Blakebrook Quarry Modification 3

Consolidation of Asphalt Plant Consent and Production Increase
State Significant Development Modification Assessment (MP 07_0020 MOD 3)

July 2021

Published by the NSW Department of Planning, Industry and Environment

Figure 3 | An AUR intersection vs a CHR-S intersection

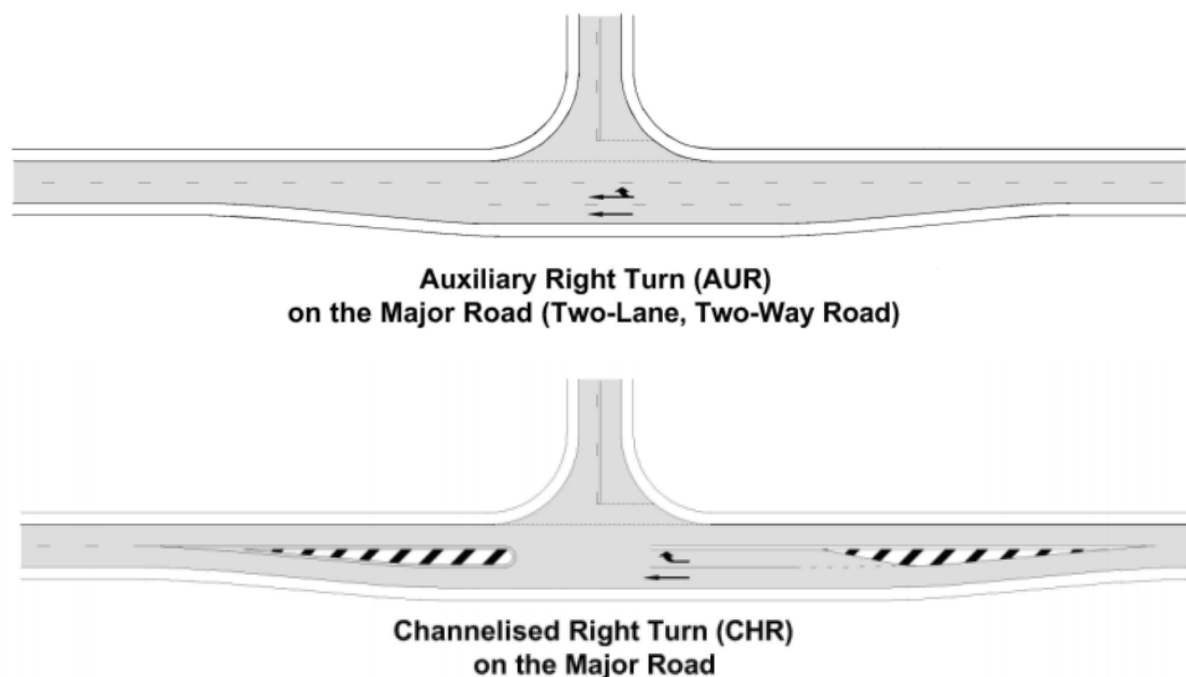
On **10 March 2020**, TfNSW provided a response reiterating previous comments regarding the preferred intersection treatment as being a shortened channelised right hand turn (CHR-S). On 12 March 2020, TfNSW further noted that the intersection treatment could be upgraded by painting new line markings at the intersection, in order to upgrade it to the preferred CHR-S.

Nevertheless, both the Department and TfNSW have recommended the intersection between the Quarry access road and Nimbin Road be upgraded to a CHR-S to align with contemporary safety standards. Council has committed to upgrade the intersection from the existing AUR standard to the preferred CHR-S intersection treatment (shown conceptually in **Figure 3**). The Department's recommended conditions would require Council to complete this upgrade prior to any increase in daily truck movements under the modification (ie prior to increasing trucking beyond currently approved levels).

On **20 October 2020** Council provided a revised intersection design which incorporated a CHR-S treatment. TfNSW confirmed in an email dated 22 October 2020, that it is satisfied with the revised design and Council has met the TfNSW requirements. This issue is discussed further in **Section 5**.
